Table A
DPE Preliminary Issues Report Responses

VICKERY EXTENSION PROJECT
Conceptual Project Rail Spur Design
Predicted Flooding Impacts

Figure 4

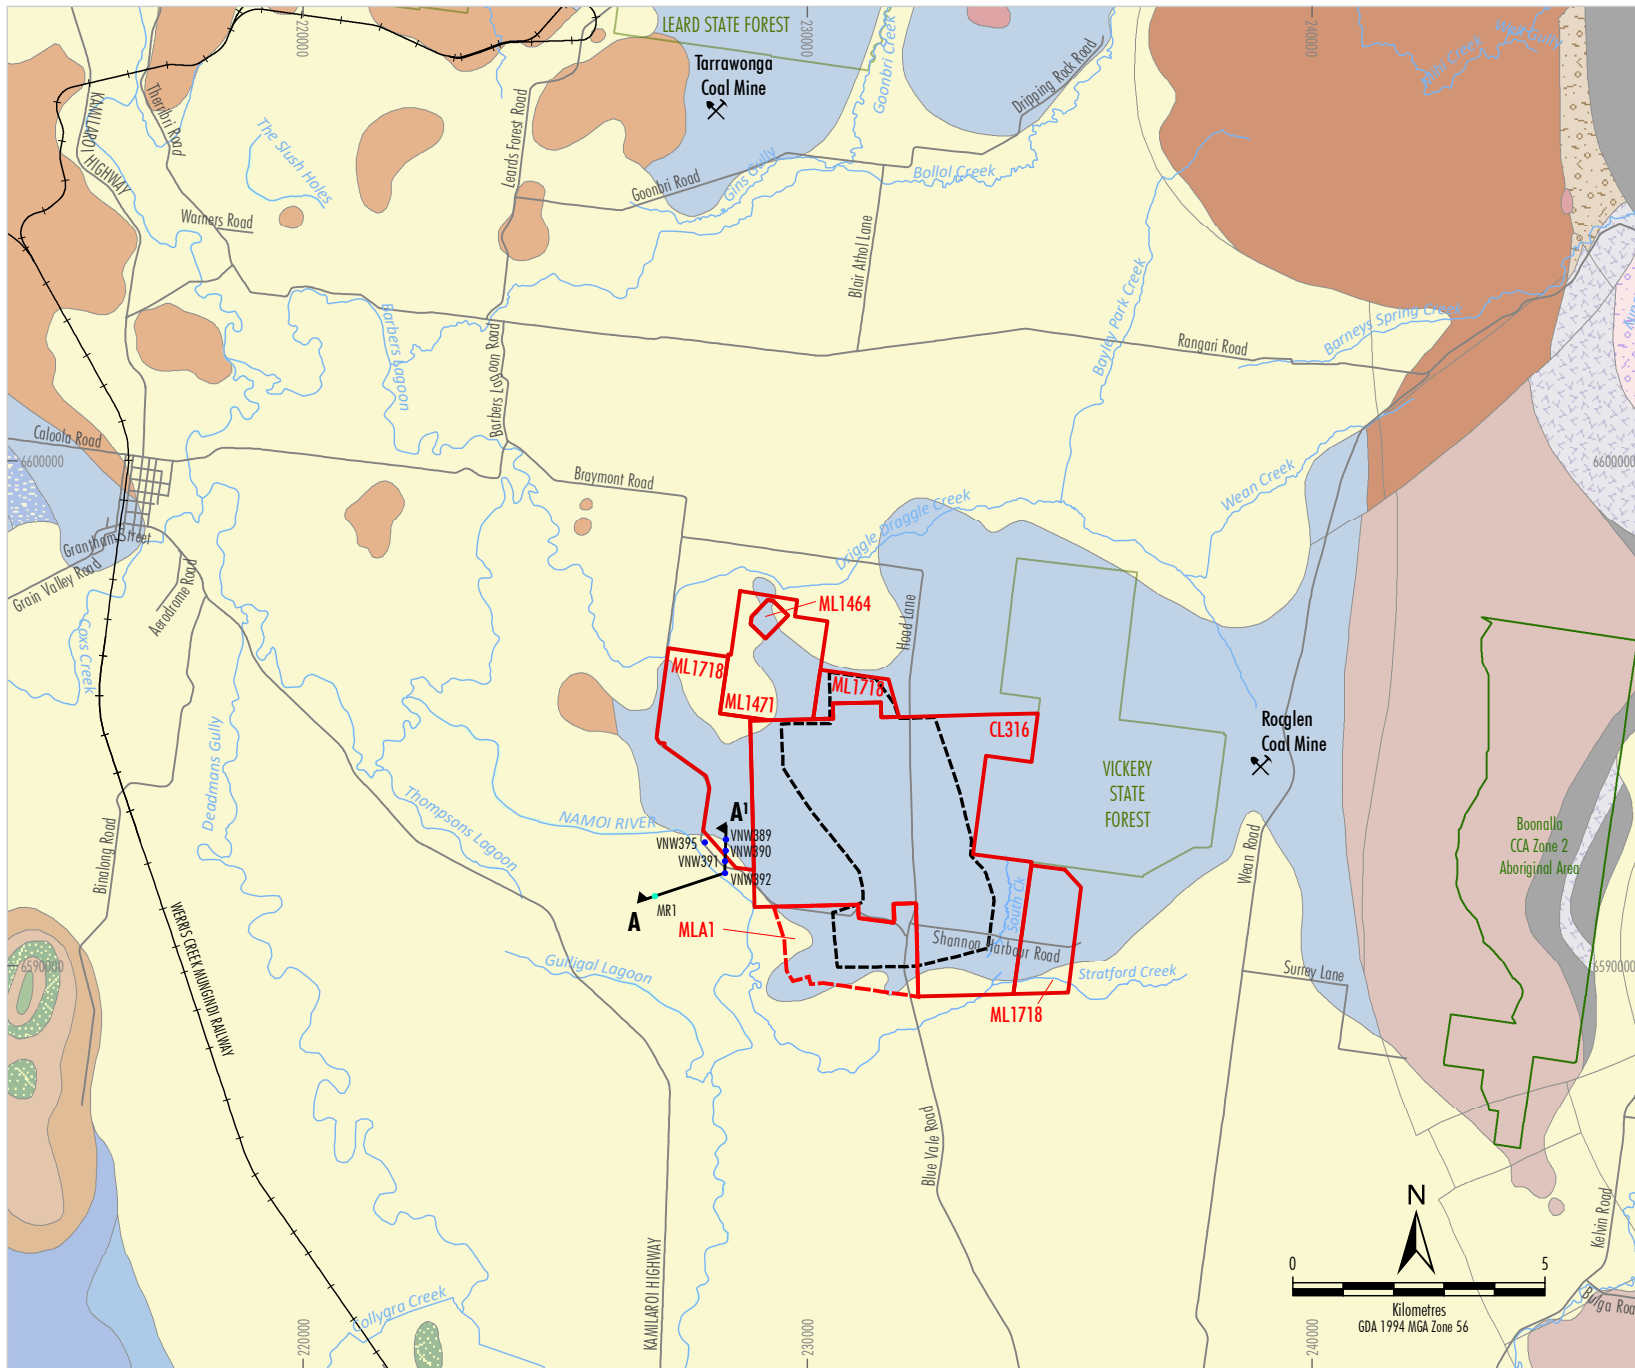
5	<p>In the Preliminary Issues Report, DPE stated “... <i>The Department’s independent groundwater expert reviewer believes that the groundwater assessment is fit for purpose for assessment and informing management strategies and licensing (see Appendix E1)</i>”.</p> <p>DPE also states “... <i>However, while some sensitivity and uncertainty scenarios have been conducted, Mr Middlemiss believes that additional sensitivity assessment is warranted to align with best practice.</i></p> <p><i>Although he acknowledges that the risk context is fairly low given the nature of the site (including the low permeability of the Maules Creek Formation and the low dewatering rates), Mr Middlemiss believes that additional qualitative and/or quantitative assessment should be undertaken to confirm the predicted impacts. The IESC also recommended additional sensitivity assessment of key hydraulic parameters to inform the assessment and potential for changes in surface and groundwater interactions.”</i></p>	<p>The Groundwater Assessment was peer reviewed by Kalf and Associates (Dr Frans Kalf) (see Attachment 4 of the EIS). The peer review undertaken by Kalf and Associates states:</p> <p><i>... The hydrogeological description, conceptualisation, model design, simulations and reporting have been conducted in a professional manner and described in detail.</i></p> <p><i>All predicted drawdown lies within the mine boundaries. No significant water table drawdown occurs within the alluvial sediments.</i></p> <p><i>Predictions of drawdown due to the proposed Extension together with the existing approved mine plan and cumulative effects will have minimal influence on the environment. No private bores would be detrimentally affected by the Extension mining proposal.</i></p> <p>In addition, the Independent Expert Scientific Committee on Coal Seam Gas and Large Coal Mining Development (IESC) stated in their advice to DPE:</p> <p><i>The IESC notes that a number of the studies completed for this project such as the surface water assessments and the studies to determine the extent of the alluvium have been completed to a high standard. The proponent should be commended for these studies and for obtaining peer reviews of many of the major reports provided in the assessment.</i></p>

Recommendation	Response
		<p>It is noted that in regard to uncertainty, DPE’s Independent Peer Reviewer for groundwater (Hugh Middlemis of Hydrogeologics) stated:</p> <p><i>While it could be argued that the risk context is fairly low in this case, given its setting in the low permeability Maules Creek Formation and benchmarking to low dewatering rates and lack of widespread drawdown impacts from nearby mines, the assessment does not highlight the use of such arguments to justify the minimum effort approach to uncertainty assessment.”</i></p> <p>Whitehaven agrees with this statement that the risk context is low, and will further elaborate on the arguments highlighted by DPE’s Independent Peer Reviewer in the Responses to Submissions.</p> <p>The regional geology of the Project area and the location of the open cut within the Maules Creek Formation is shown on Figure 4. A cross-section of the alluvium associated with the Namoi River west of the Project mining area is provided in Figure 5.</p> <p>The DPE’s Independent Peer Reviewer also stated:</p> <p><i>Even after improved uncertainty assessments, uncertainties will remain, and the ongoing monitoring program is well designed to provide the data in due course for model improvements and assessment of uncertainties.</i></p> <p>Whitehaven agrees with this recommendation to assess model uncertainty through comparison to monitoring data.</p> <p>Uncertainty analysis was undertaken for the Project Groundwater Assessment (Section 7.2. of Appendix A of the EIS). The modelled vertical hydraulic conductivity was varied by an order of magnitude (i.e. a factor of 10) for all model layers and resultant outcomes (-8% and +16%) indicated the model results were not significantly sensitive to this significant change in conductivity and therefore, the model had negligible uncertainty.</p> <p>On this basis, additional quantitative sensitivity analysis is considered to have limited benefit and is therefore not considered to be necessary.</p> <p>Note in the Preliminary Issues Report, DPE states “... drawdown from the proposed project is predicted to be less than that predicted from the Approved Mine.”</p>

Figure 6: Conceptual Final Landform – Rehabilitation Areas

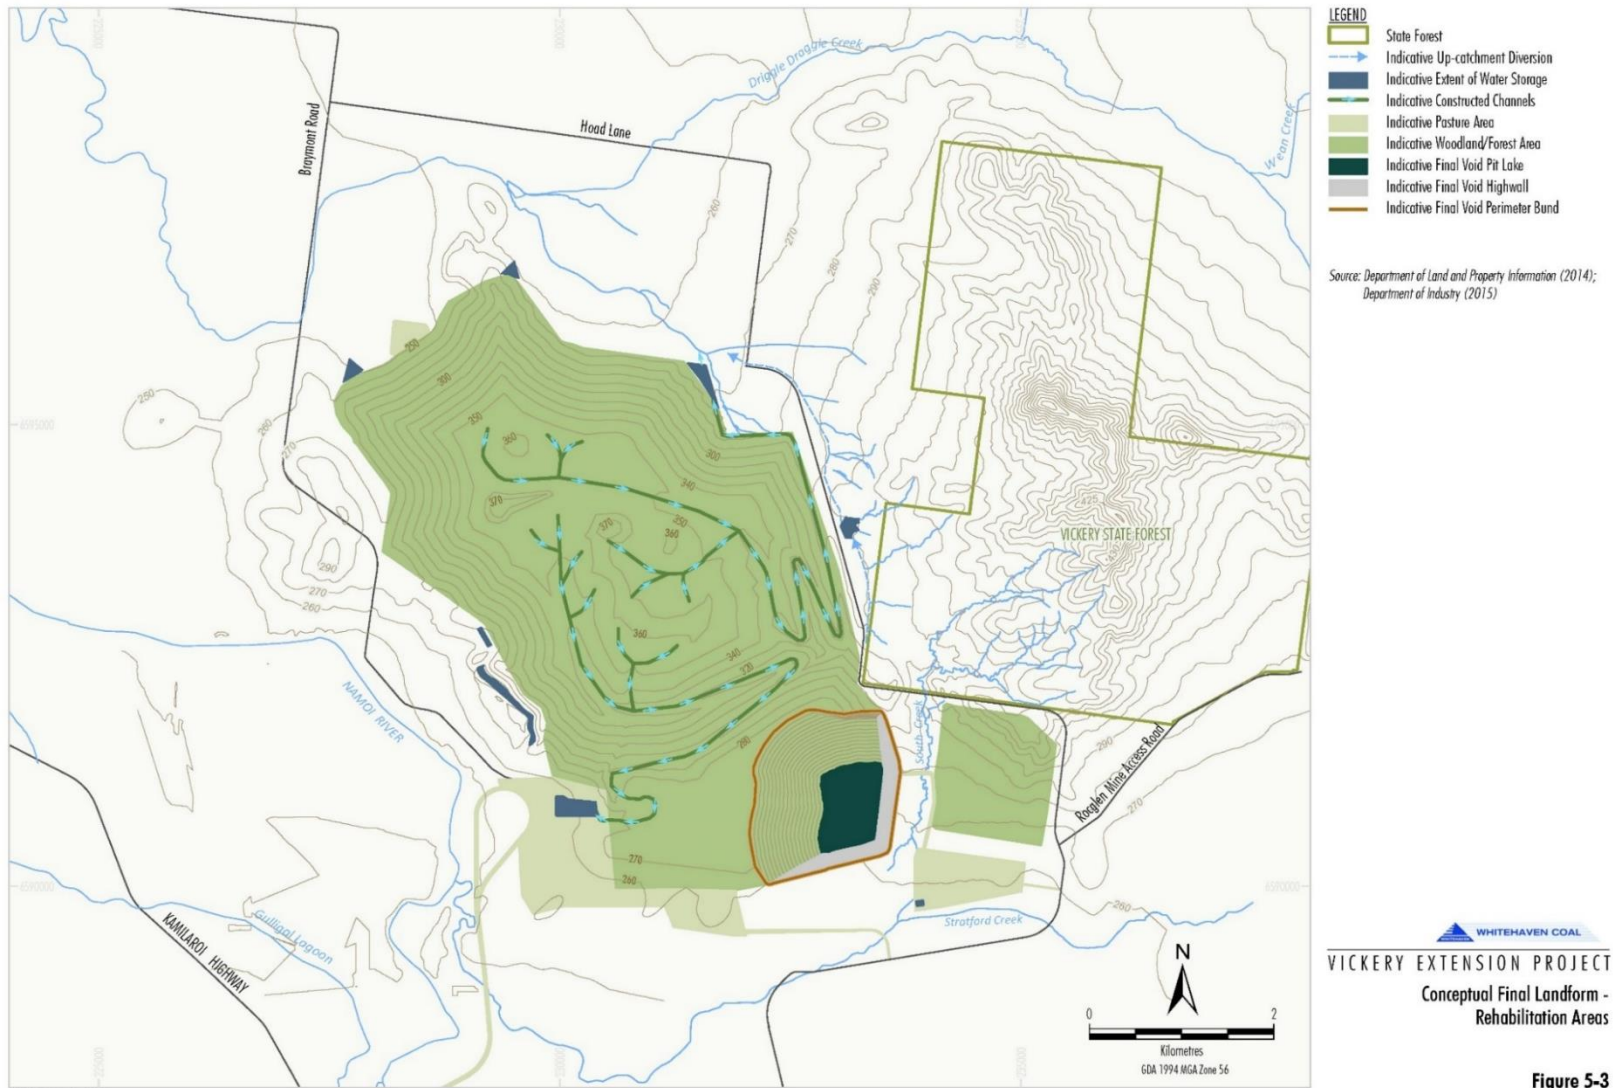
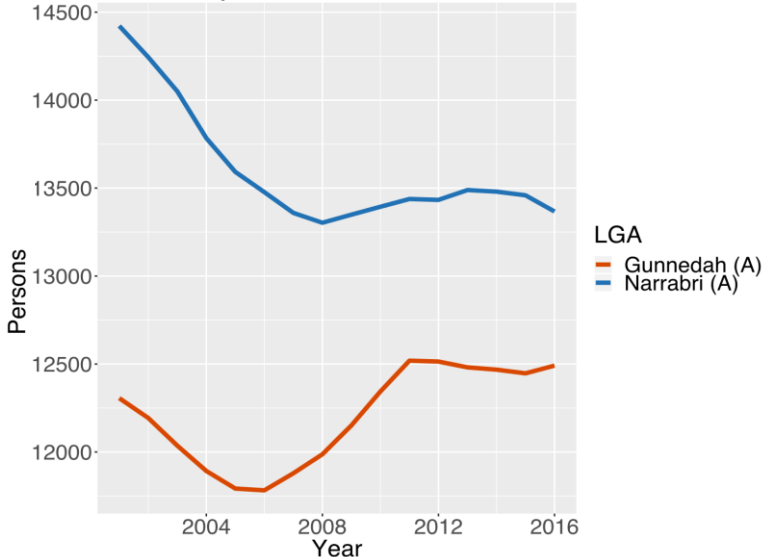
Recommendation	Response
Final Land Use		
11	<p>In the Preliminary Issues Report, DPE states “... DPI, Gunnedah Shire Council, Narrabri Shire Council and some public submitters recommended that rehabilitation should aim to maximise the area of land suitable for future sustainable agricultural land use. Narrabri Shire Council has recommended that Whitehaven rehabilitates the mine to provide at least 900 ha of Class 3 agricultural suitability land (ie. similar to the area of Class 2 and 3 land that would be disturbed).</p> <p>While this would conflict with the proposed biodiversity conservation outcomes for the project, the Department agrees that detailed consideration of the rehabilitation strategy and post-mining land use is warranted for the project in consultation with relevant stakeholders, to ensure the highest and best use of the land is achieved over the long term.</p>	<p>It is noted that, in addition to the Narrabri Shire Council’s (NSC’s) request for provision of at least 900 ha of Class 3 suitable agricultural land, Gunnedah Shire Council’s (GSC’s) submission to the EIS states:</p> <p style="padding-left: 40px;"><i>Council implores the developer to consider implementing suitable biodiversity offsets within the development site itself or on immediate adjoining allotments, to ensure that the endangered ecological communities present within the immediate area are not faced with destruction and reduction in available habitat.</i></p> <p>In addition, as noted in the DPE’s Preliminary Issues Report (page 20), public objections to the EIS raised concerns in regard to the use of land (that could otherwise be used for agriculture) for biodiversity offsets.</p> <p>Consistent with this feedback, the overall rehabilitation goal for the Project is to enhance the cover and connectivity of native woodland on the final landform between the Vickery State Forest and the Namoi River, maximising the ability to meet Federal and State biodiversity offset requirements, while returning some areas of the final landform to agricultural land capable of supporting grazing.</p> <p>Sections of the Project mining area to be rehabilitated to agricultural land include the mine infrastructure area, the southern part of the secondary infrastructure area, water management dams (except those retained for agricultural purposes or as passive water control storages) and the Project rail spur corridor (see Figure 5-3 of the EIS, reproduced as Figure 3 below).</p> <p>Rehabilitation of areas of the Project mining area to woodland/forest has been strategically selected consistent with the surrounding existing land uses (e.g. vegetation and fauna habitat in the Vickery State Forest and along the Namoi River) and to provide a biodiversity corridor linking the Vickery State Forest and the Namoi River. This biodiversity corridor would also be extended by proposed rehabilitation of the Rocglen Coal Mine to the immediate east of the Vickery State Forest.</p> <p>If the waste rock emplacement were to be rehabilitated to agricultural land, Whitehaven may need to secure additional areas for biodiversity conservation in perpetuity outside the Project mining area to meet its offset obligations. This may result in the sterilisation of existing agricultural land.</p>
